CLARK COUNTY, NEVADA BID NO. 603798-15 PEARSON PARK: TRACK & FIELD RENOVATION PROJECT

ADDENDUM NO. 2

SK-1

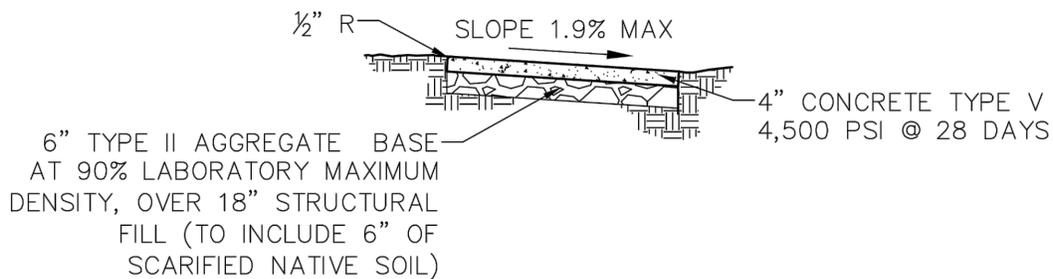
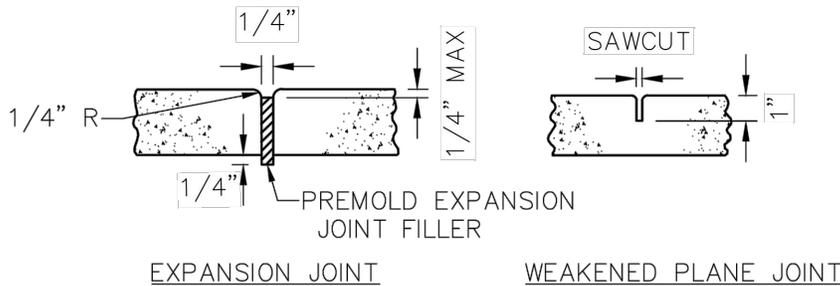
6. **Add:** Sheets SK-1, SK-2, SK-3, SK-4, SK-5, SK-6, SK-7, dated September 25, 2015.
7. **Add:** Sheets SK-8, SK-9, SK-10, dated September 28, 2015.
8. **Add:** SK-11, dated September 29, 2015.
9. **Delete** DETAIL 3 of Sheet DT-001: SIDEWALK CROSS SECTION – CROSS GRADE. **Replace with** DETAIL 3, SIDEWALK CROSS SECTION – CROSS GRADE. **See SK-1.**
10. **Delete** DETAIL 2, of Sheet DT-003: POWER & COMMUNICATION CABLES & SPARE CONDUIT TRENCH DETAIL. **Replace with** DETAIL 2, POWER & COMMUNICATION CABLES, & SPARE CONDUIT TRENCH DETAIL. **See SK-2.**

4. QUESTION – Per 3/DT-001 expansion joints are ½” and weakened plane joints ¼” with 1/8” radius tools. On previous Clark County Parks, ¼” expansion with sawcut weakened plane joints have been required. Please confirm this will not be required.

ANSWER – Refer to **revised 3/DT-001, SK-1**, attached to this Addendum No. 2.

SK-3

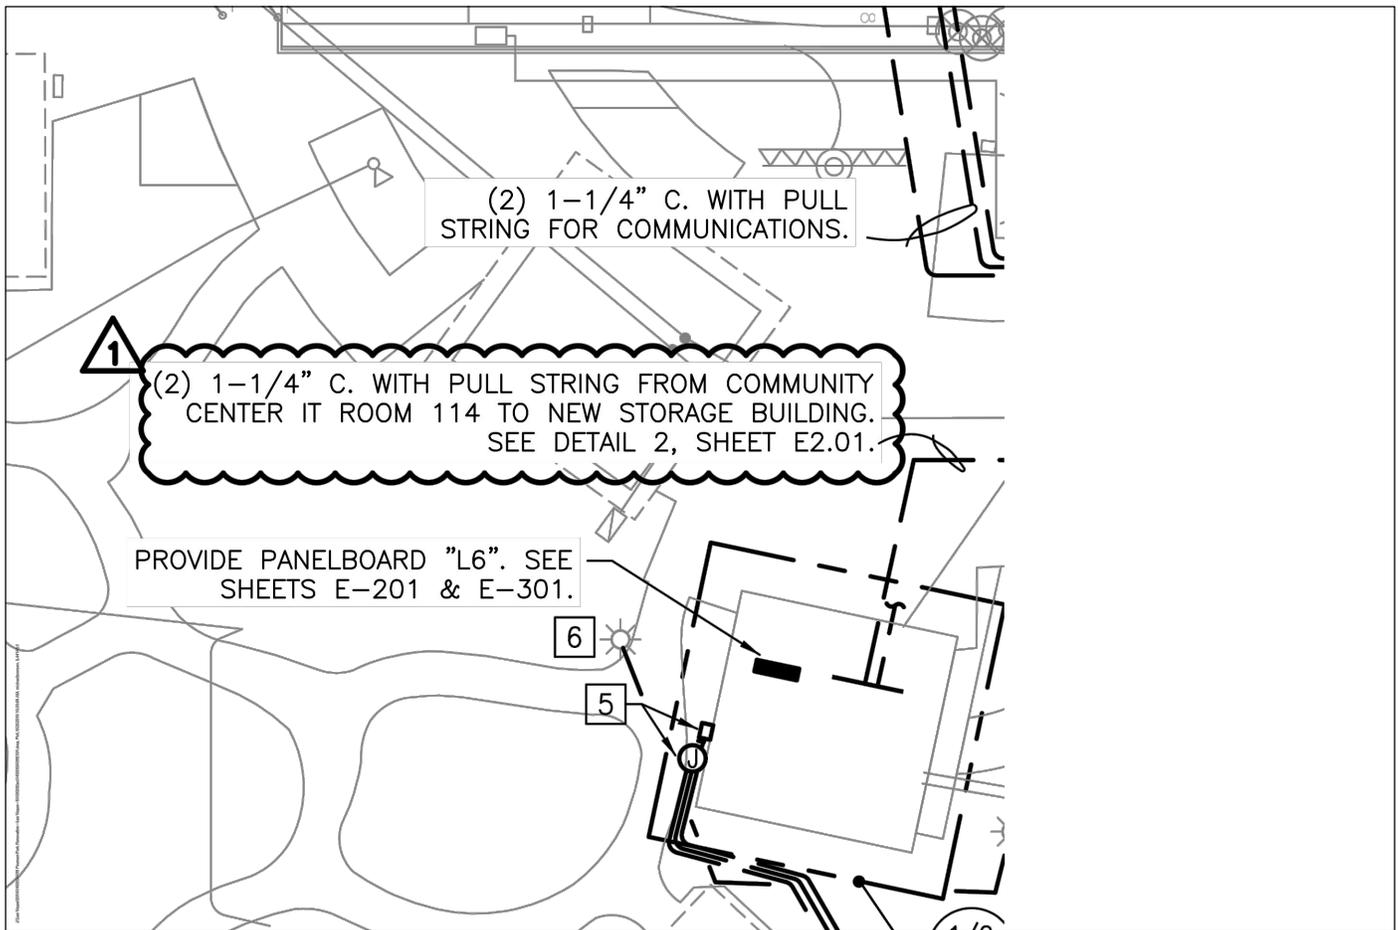
11. Sheet CU-001: **Remove:** "CONSTRUCTION NOTES, Note 61. TRENCH AND CONSTRUCT FIVE (5) CONDUITS – ONE (1) 1-1/4" COMMUNICATIONS, ONE (1) 2" POWER, AND THREE (3) 2" SPARE CONDUITS PER DETAIL 2/DT-003. SAWCUT AND PATCH CONCRETE TO MATCH EXISTING PER DETAIL 2/DT-001 AND ASPHALT PER DETAIL 1/DT-001." **Replace with:** "CONSTRUCTION NOTES, Note 61. TRENCH AND CONSTRUCT POWER AND COMMUNICATIONS CONDUITS PER ELECTRICAL SITE PLAN E-101. CONSTRUCT PER DETAIL 2/DT-003. SAWCUT AND PATCH CONCRETE TO MATCH EXISTING PER DETAIL 2/DT-001 AND ASPHALT PER DETAIL 1/DT-001." **See SK-3**

12. Sheet CU-001: **Remove:** "CONSTRUCTION NOTES, Note 63. TERMINATE THREE (3) SPARE CONDUITS AND ONE (1) POWER CONDUIT AT MECHANICAL ROOM. CONNECT POWER TO EXISTING PANEL (REFER TO ELECTRICAL DRAWINGS)". **Replace with:** "TERMINATE ELECTRICAL FEEDER CONDUIT(S) AT EXISTING PANEL AS INDICATED IN ELECTRICAL SITE PLAN E-101. RUN CONDUIT THROUGH MECHANICAL ROOM TO PANEL. FIRE SEAL ALL PENETRATIONS." **See SK-3**

13. Sheet CU-001: **Remove:** "CONSTRUCTION NOTES, Note 64. TERMINATE ONE (1) TELECOMMUNICATIONS CONDUIT AT IT ROOM 914. RUN OVERHEAD INSIDE BUILDING ENVELOPE". **Replace with:** "CONSTRUCTION NOTES, Note 64. TERMINATE TELECOMMUNICATIONS CONDUIT(S) AT IT ROOM 914 AS INDICATED IN ELECTRICAL SITE PLAN E-101. RUN CONDUIT(S) OVERHEAD THROUGH OPEN CEILING STORAGE ROOM TO IT ROOM. FIRE SEAL ALL PENETRATIONS." **See SK-3**

14. Sheet CU-001: **Remove:** "CONSTRUCTION NOTES, Note 73. CONSTRUCT TEN (10) CONDUITS – FIVE (5) IN AND FIVE (5) OUT". **Replace with:** "CONSTRUCTION NOTES, Note 73. PROVIDE COMMUNICATIONS AND POWER TO BUILDING D AS INDICATED IN ELECTRICAL SHEETS E-101 AND E-201." **See SK-3**

6. QUESTION – Per note 64/CU-001, one conduit is to terminate inside the building. How/where is this conduit required to enter the building?

7. QUESTION – Per note 64/CU-011, one conduit is to terminate inside the building routed overhead inside the building envelope. Please provide ceiling type overhead, number of partitions to pass through if any, and identify if there are any rated partitions.

8. QUESTION – Per note 61/CU-001, five conduits are routing to the IT room north of the Community Center where this note is called out. But the plan appears to show three (3) conduits. Per Note 64, one (1) tel conduit terminates in Room 914. Please clarify the number of conduits. What happens to the remaining conduits?

9. QUESTION – Per note 61/CU-001, five (5) conduits are routed to the Mechanical room, south of the Community Center where this note is called out, but the plan appears to show four (4) conduits. Per Note 63, there should be four (4) conduits. Please clarify.

10. QUESTION – Note 73/CU-001 calls for the construction of ten (10) conduits – five (5) in and five (5) out; the plan does not appear to show ten (10) conduits and this note seems to conflict with notes 61, 63, and 64. Please clarify.

ANSWER – Refer to revised note 64/CU-001, **SK-3**, attached to this Addendum No. 2.

ANSWER – Refer to revised note 61/CU-001, **SK-3**, attached to this Addendum No. 2, and revised sheet E-101, **SK-4**, also attached to this Addendum No. 2.

ANSWER – Refer to revised note 61/CU-001, **SK-3**, attached to this Addendum No. 2, and revised sheet E-101, **SK-4**, attached to this Addendum No. 2.

ANSWER – Refer to revised note 73/CU-001, **SK-3**, attached to this Addendum No. 2, and revised sheet E-101, **SK-4**, attached to this Addendum No. 2.

SK-8

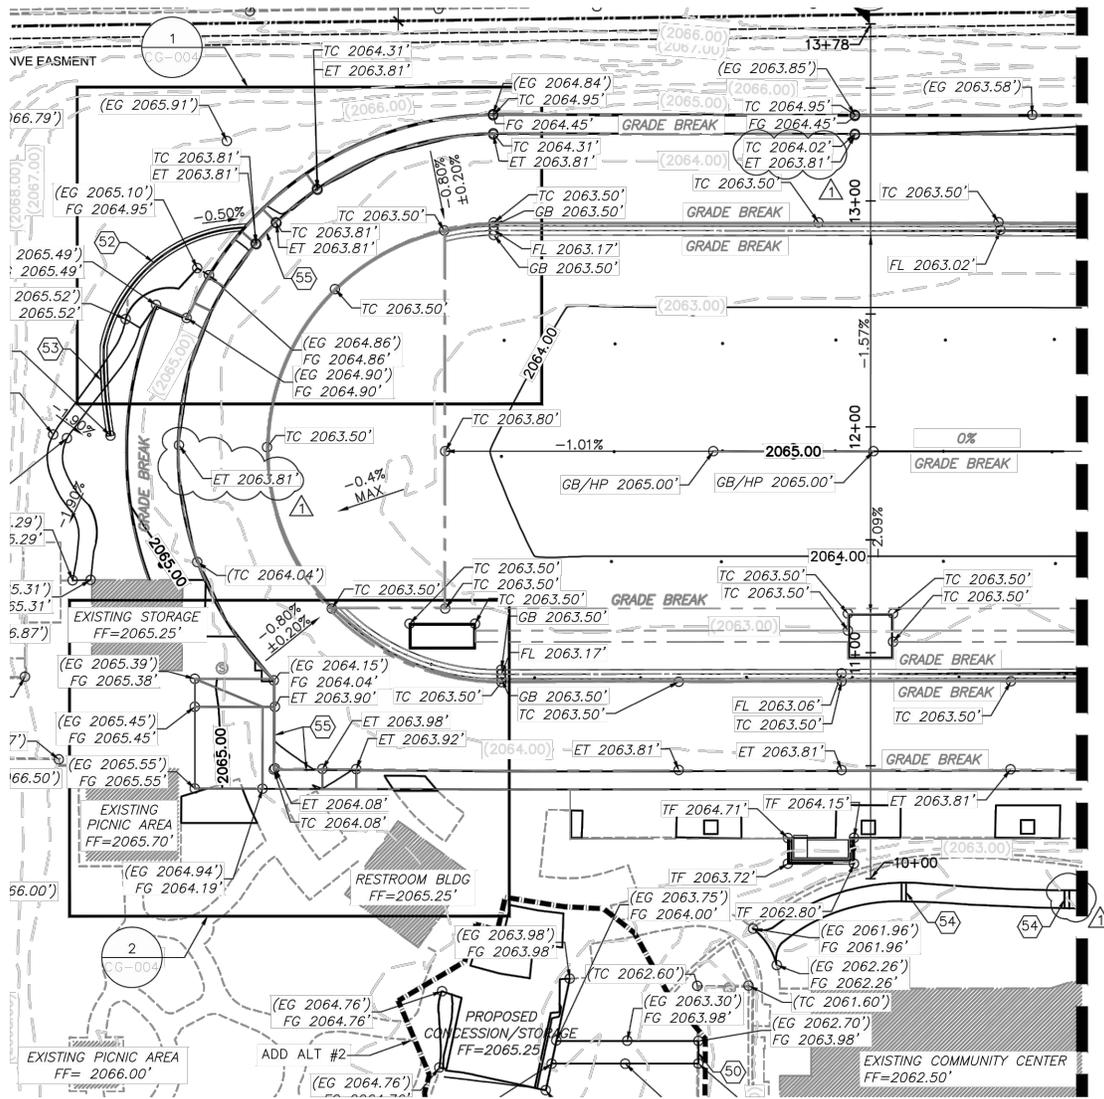
18. Add: "EQUIPMENT MATRIX on Sheet AV-000." **See SK-7.**
19. **Remove:** CLOUDED CALL-OUTS on Sheet CG-001 and **Replace** with CLOUDED CALL-OUTS. See SK-8.

22. QUESTION – The elevations from detail 1-CG-004, 2-CG-004 and 4-CG-004 are different from the elevations on the grading plan GC-001 and CG-002. I have attached a copy of pages CG-001 and CG-002 to show which elevations are off, Please clarify.

ANSWER – Refer to revisions to Sheets CG-001, CG-002, CG-004, SK-8, SK-9, and SK-10, attached to this Addendum No. 2.

SK-9

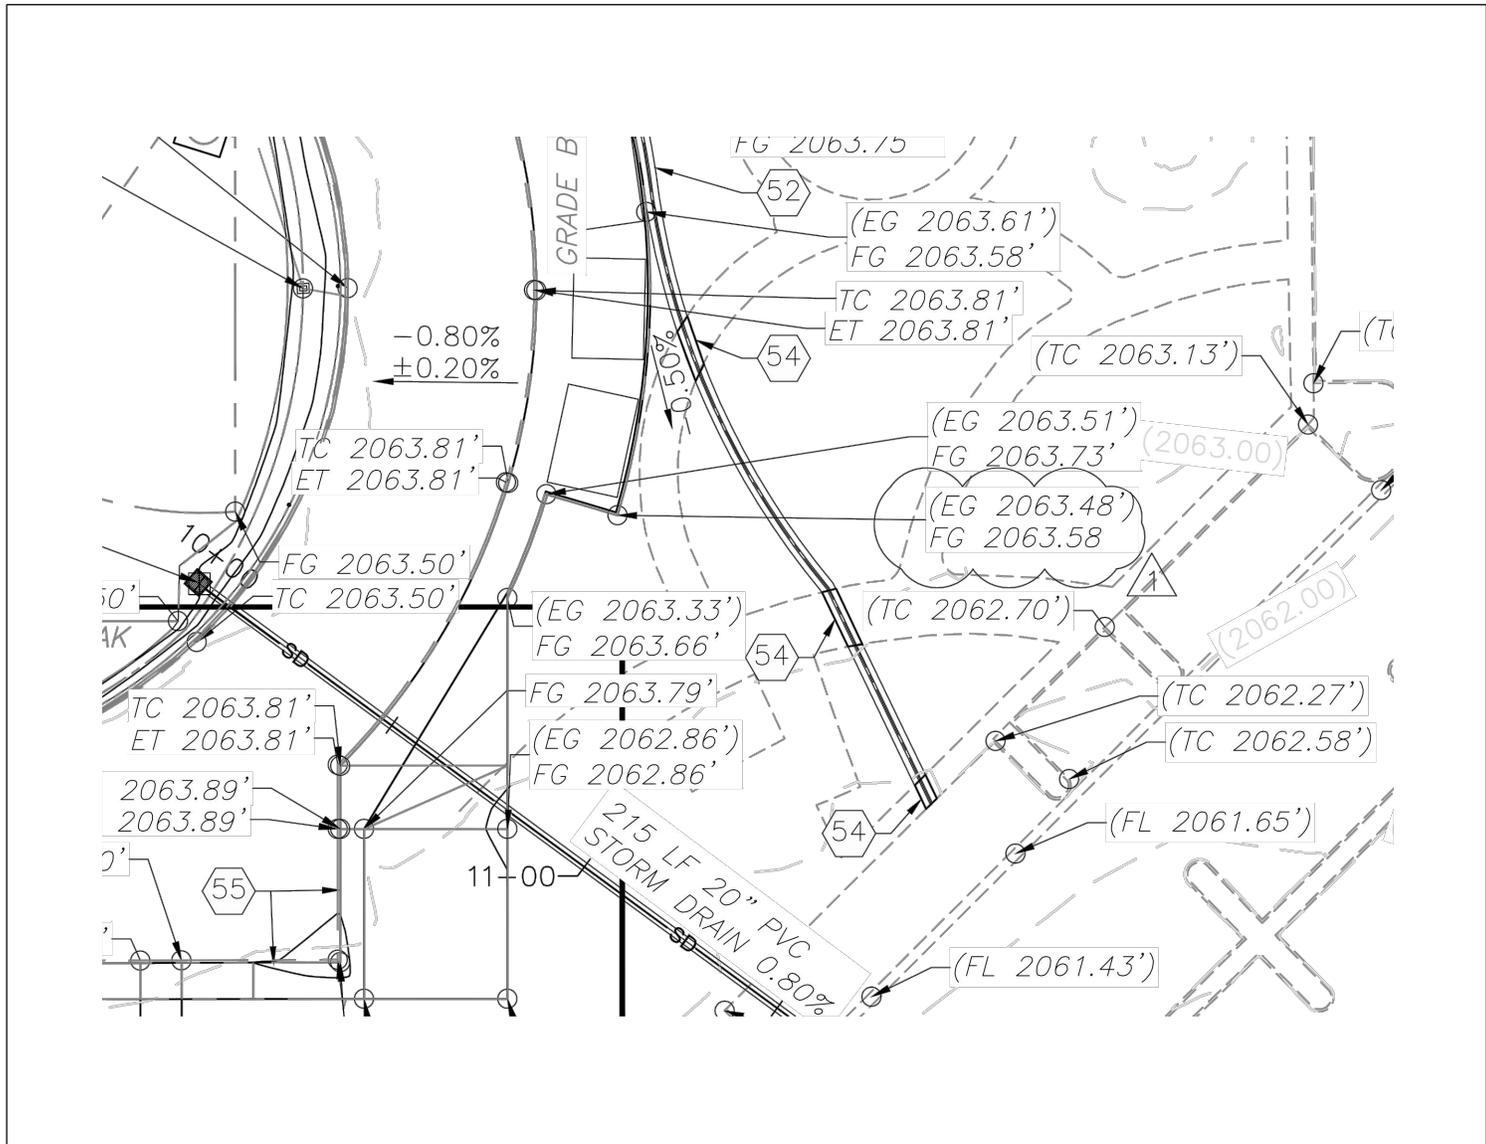
20. **Remove:** Clouded Call Outs on Sheet on CG-002: and **Replace** with Clouded Call Outs See SK-9.
21. **Remove:** AUDIO/VIDEO SITE PLAN NOTES: Note No. 8 on Sheet CG-004 and **Replace** with AUDIO/VIDEO SITE PLAN NOTES: Note No. 8. **See SK-11.**
